**CITY OF ROCKVILLE PLANNING DIVISION
STAFF REPORT**

August 23, 2000

Detailed Application CPD2000-0004D for
Comprehensive Planned Development
CPD1999-0004, Fallsgrove

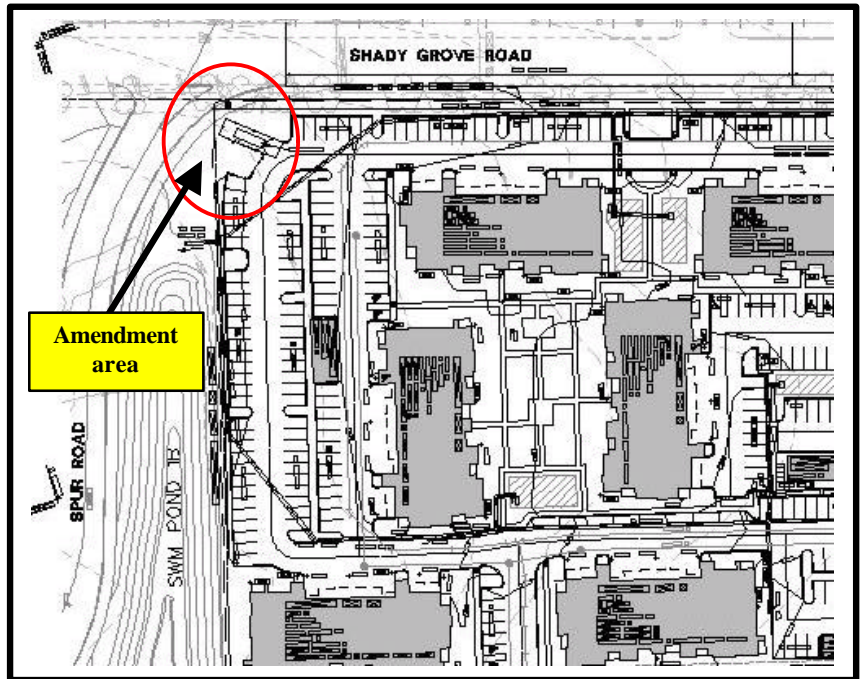
8. That the area of the site plan, outlined on Planning Commission Exhibit "A" (and shown at right) be modified to show compatibility and consistency with the approved plan for the spur road connection as approved via Detailed Application CPD2000-0004H. A property line adjustment may be required as part of this condition. Property line adjustment and site plan modifications must be shown on the final plat and signature set of drawings for the project.
